**STATE OF HAWAII
DEPARTMENT OF TRANSPORTATION
HIGHWAYS**

**ADDENDUM NO. 2
FOR
TRAFFIC SIGNAL MODERNIZATION, OAHU, PHASE 2A
DISTRICT OF HONOLULU
ISLAND OF OAHU
FEDERAL-AID PROJECT NO. STP-0300(214)**

NOVEMBER 8, 2024

FED. ROAD DIST. NO.	STATE	PROJ. NO.	FISCAL YEAR	SHEET NO.	TOTAL SHEETS
HAWAII	HAWAII	STP-0300(214)	2024	ADD. 18	149

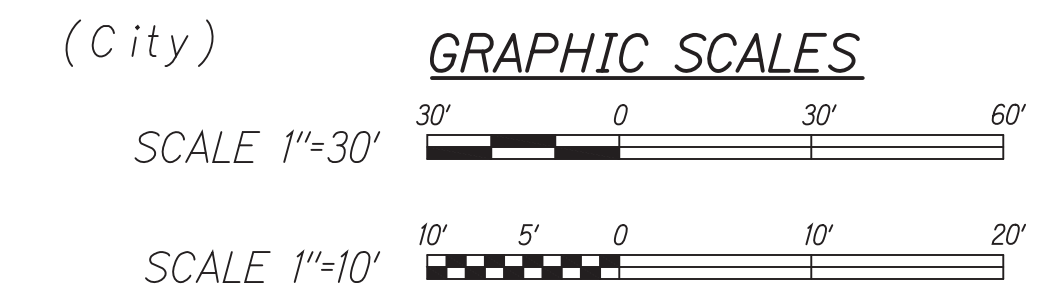
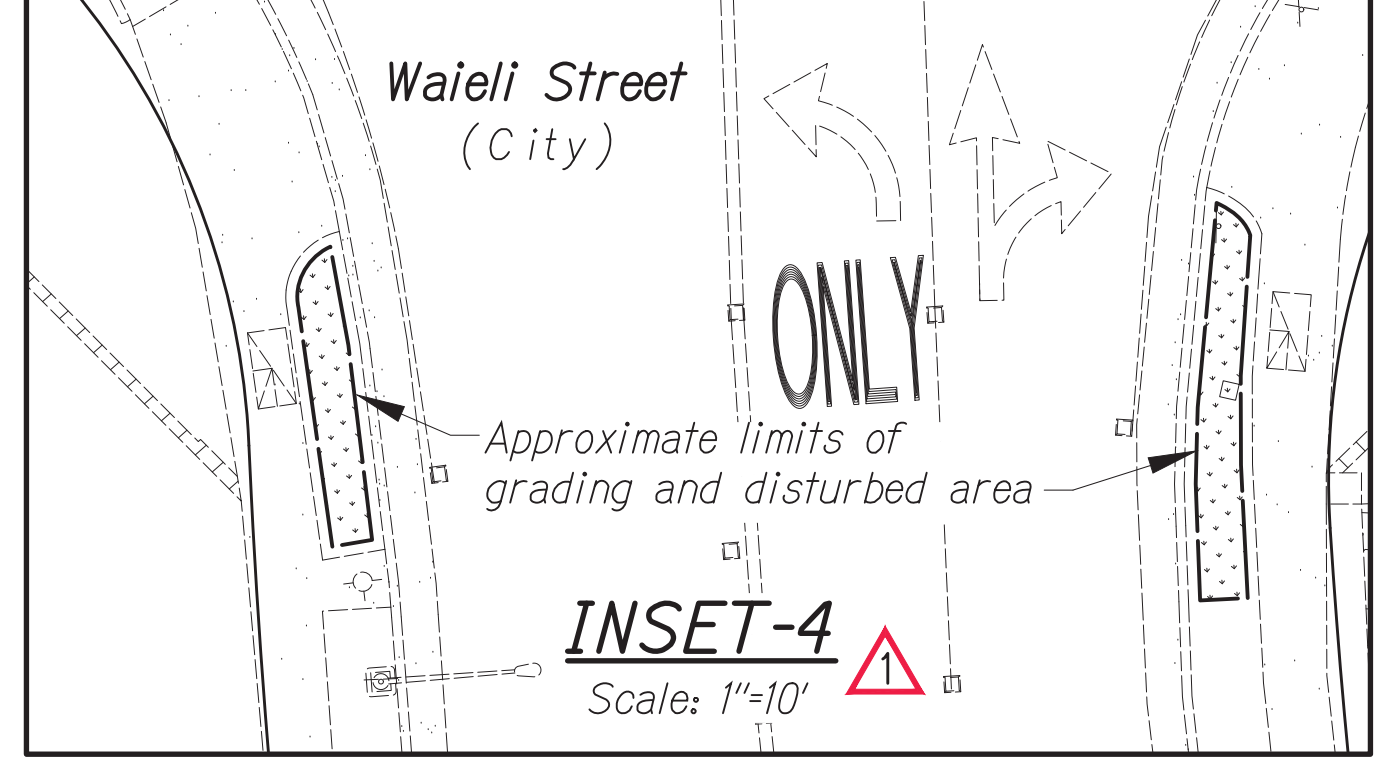
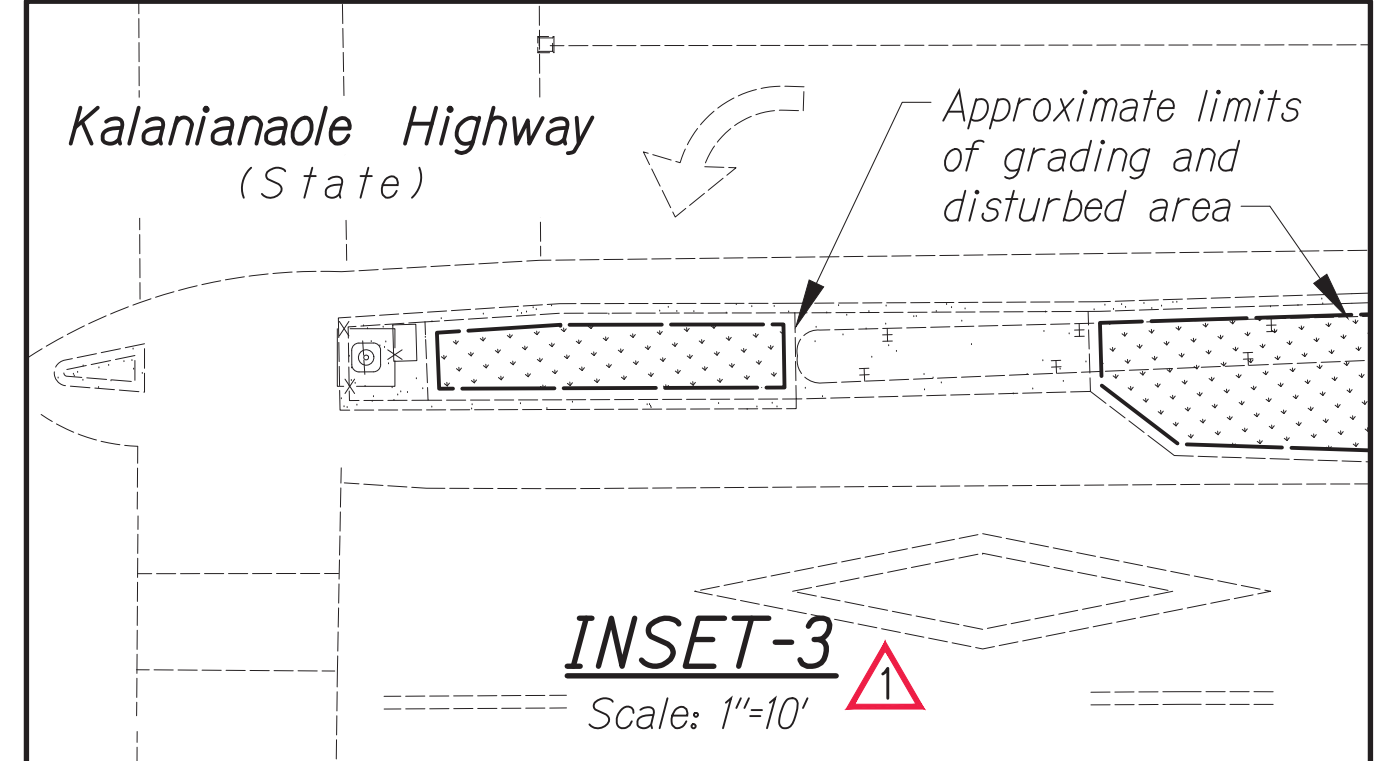
DATE	REVISION
11/8/24	Added approximate Limits of Grading and Disturbed Area (limits of clearing and grubbing). Added compost filter sock at drain inlet adjacent to Kalani High School.

HDOT response: The area to be cleared and grubbed is shown on the INSETs on sheet ADD. 18, Erosion and Sediment Control Plan (ESCP). It is called out as "Approximate Limits of Grading and Disturbed Area".

FED. ROAD DIST. NO.	STATE	PROJ. NO.	FISCAL YEAR	SHEET NO.	TOTAL SHEETS
HAWAII	HAWAII	STP-0300(214)	2024	ADD.97	149

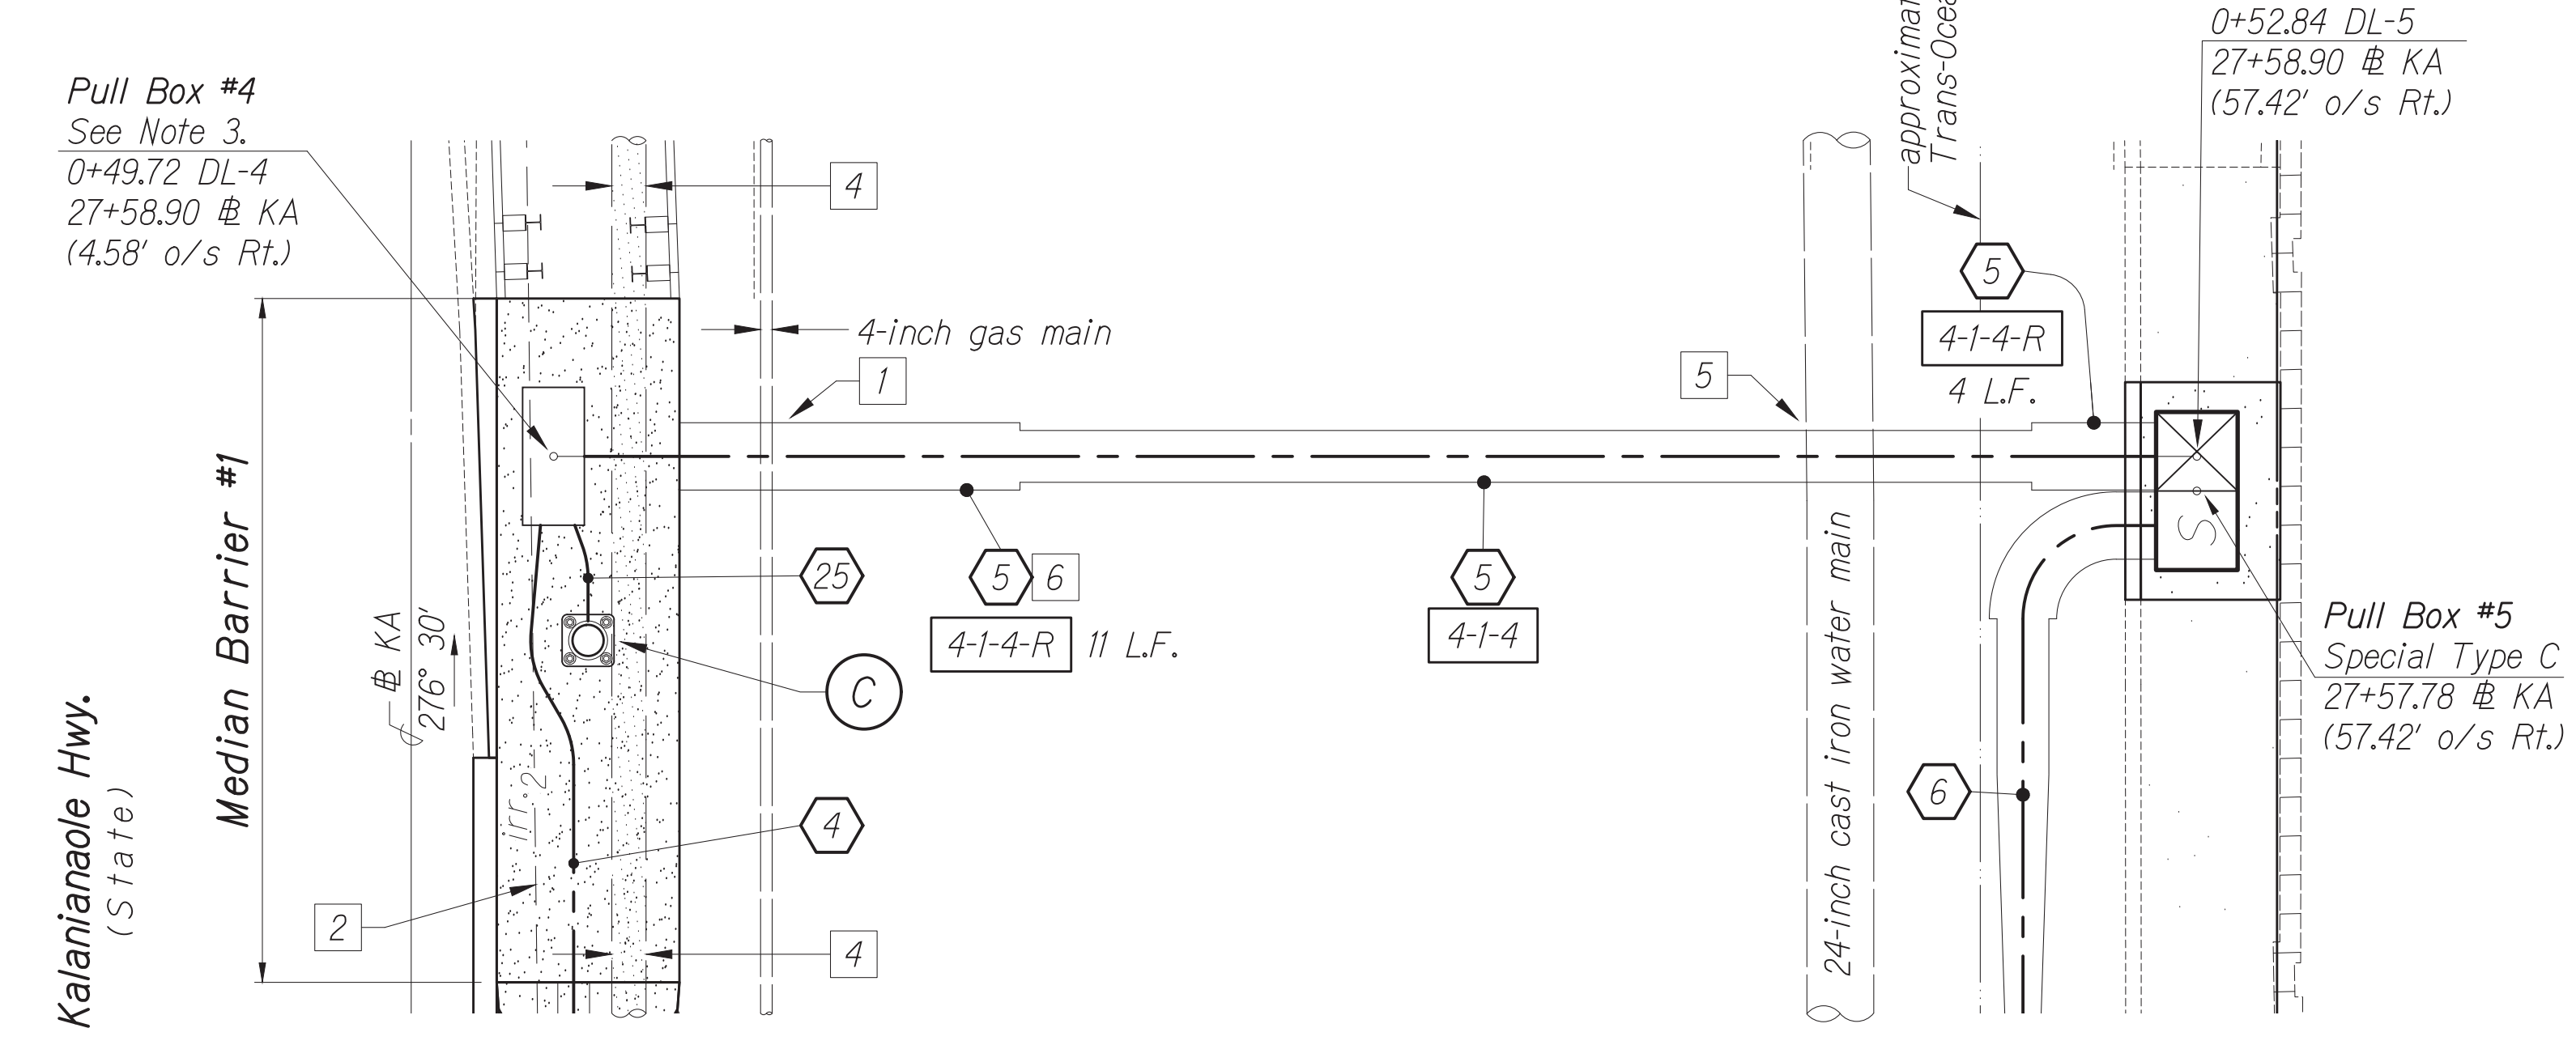
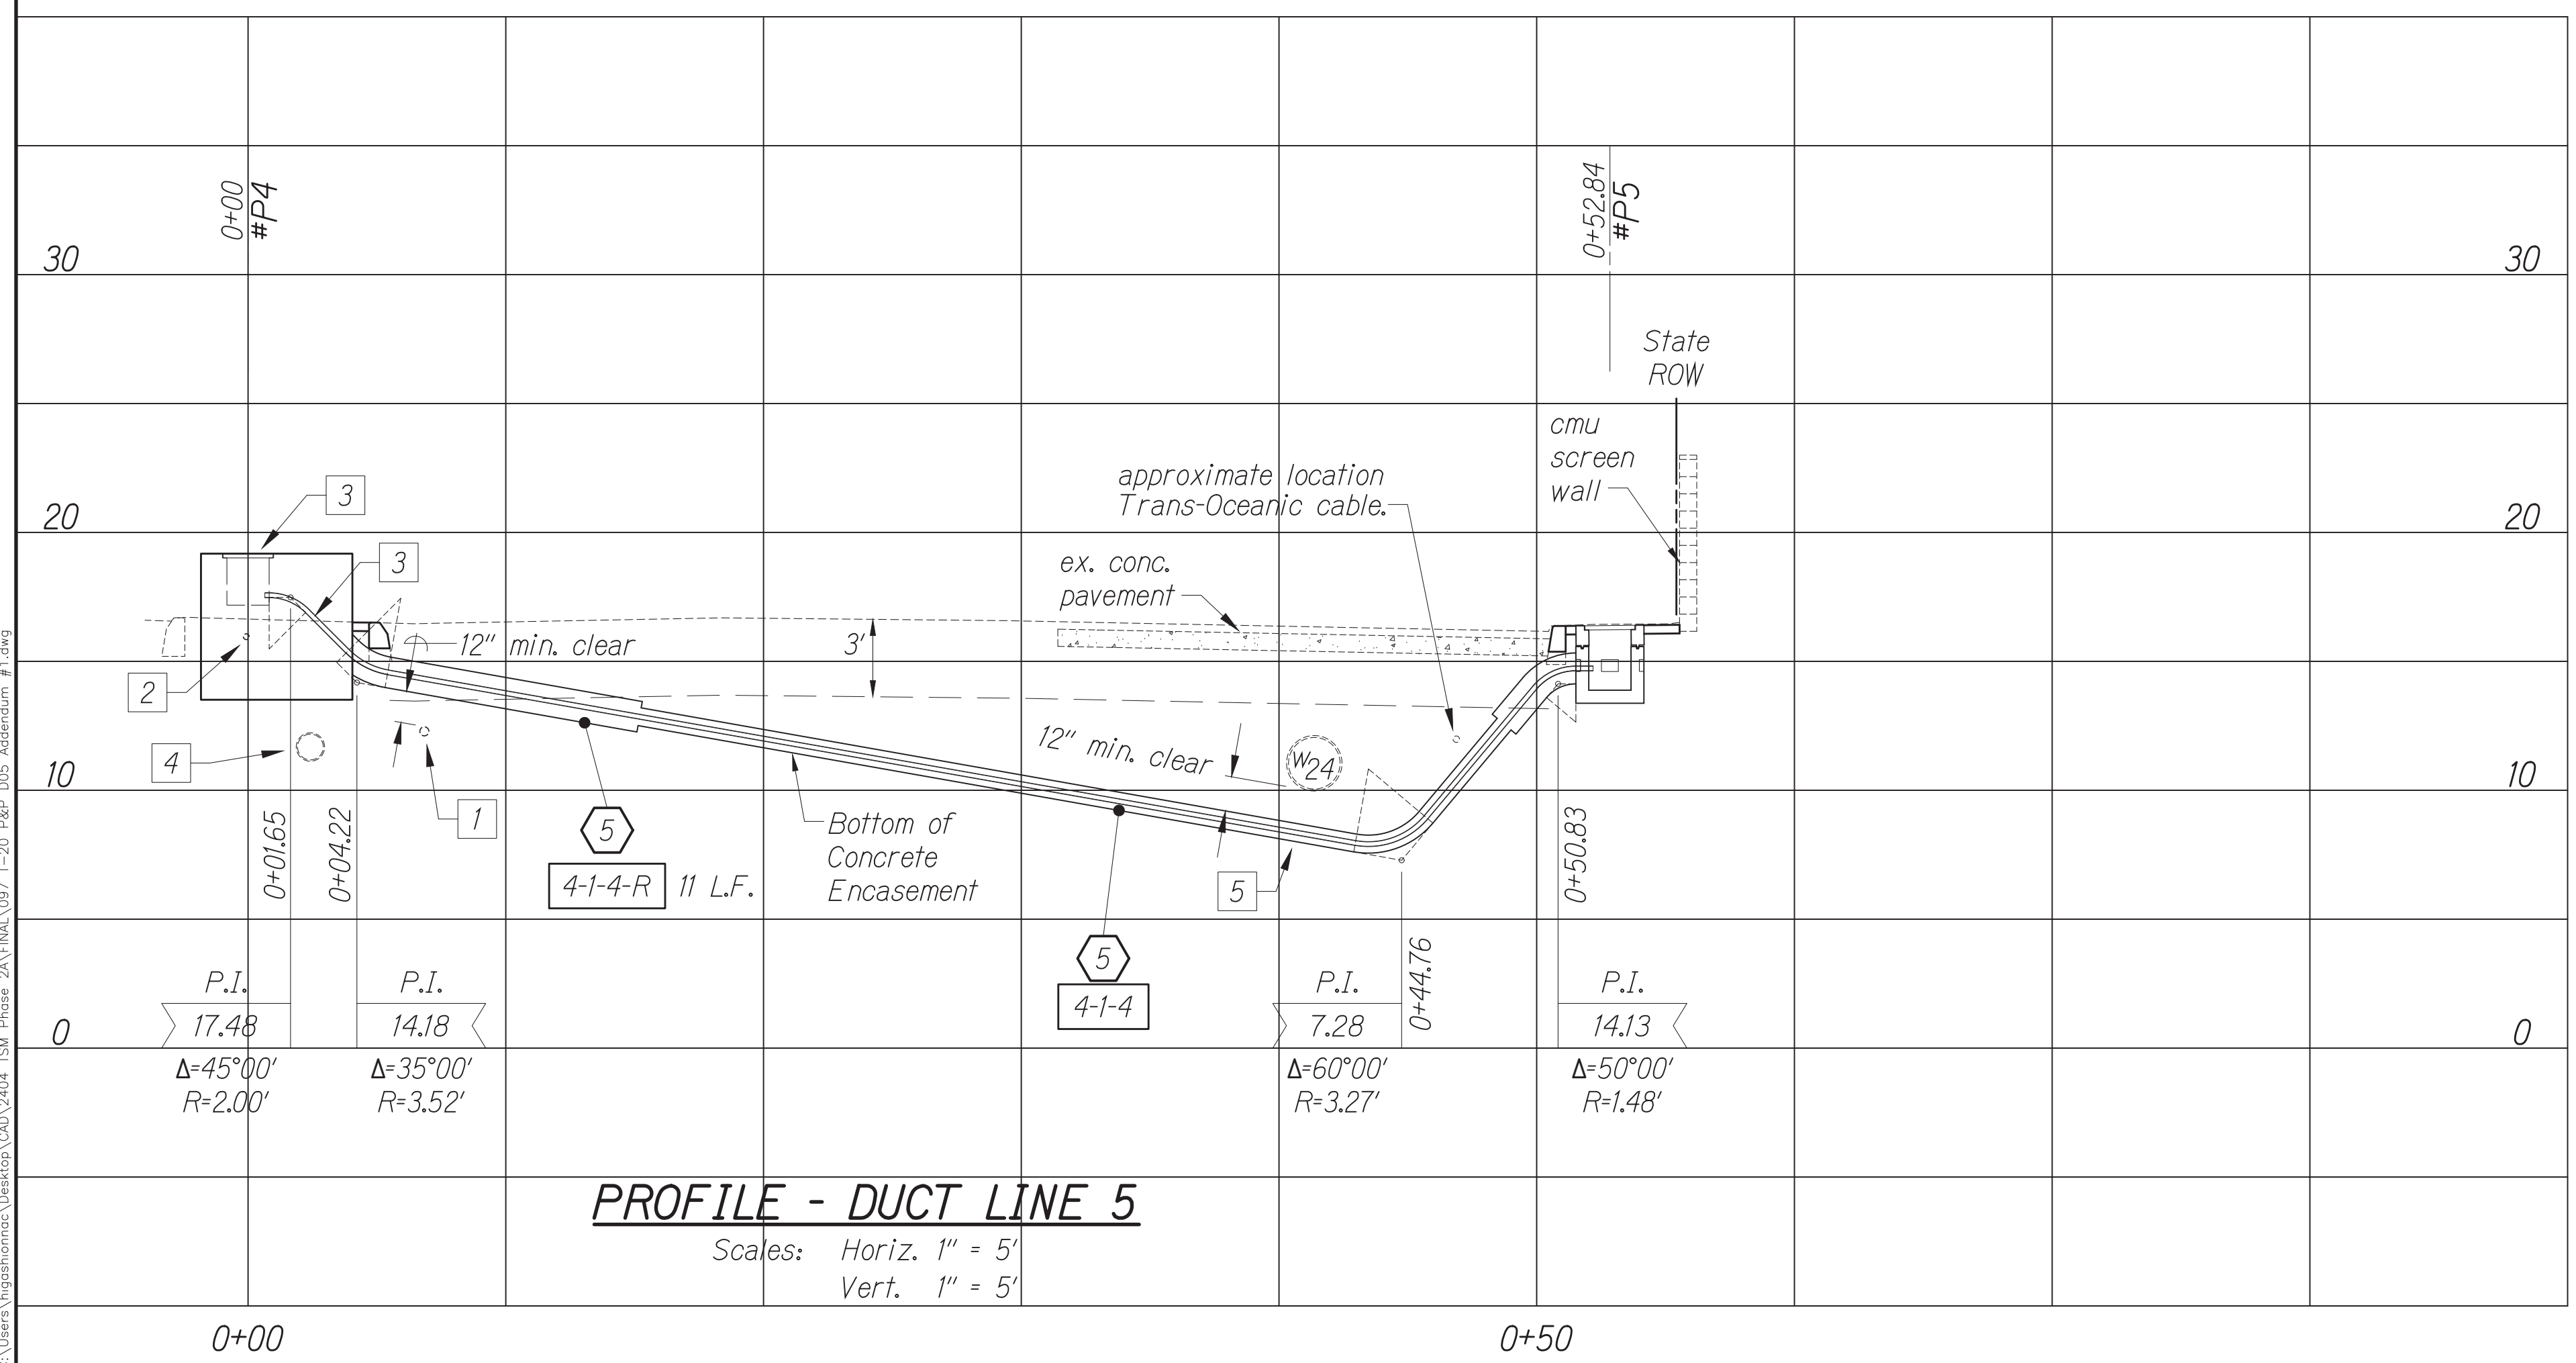
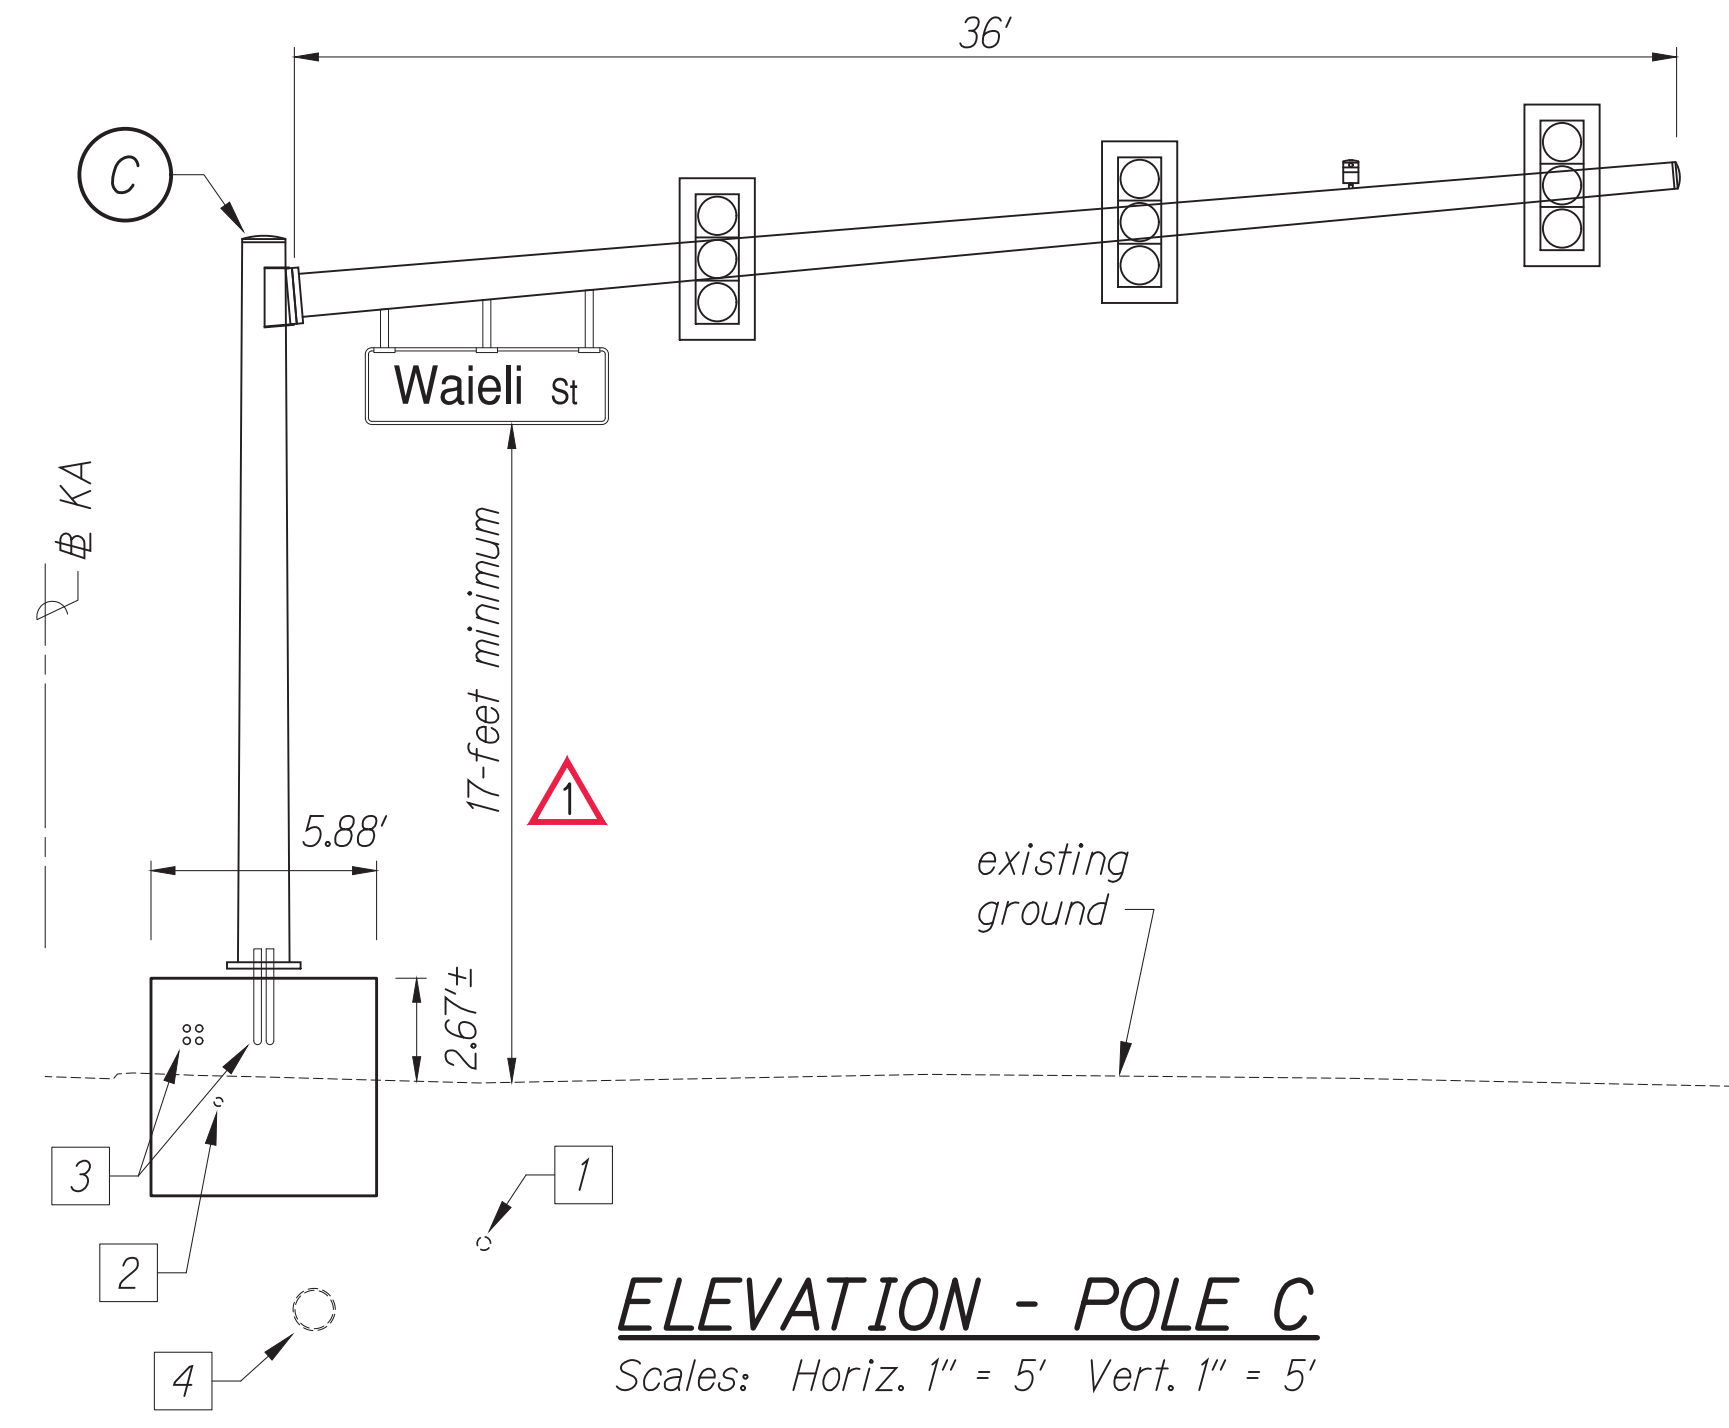
Revised call out to 17-foot minimum clearance (in lieu of 15-foot) from bottom of street name sign on mast arm to top of pavement of travel lane.
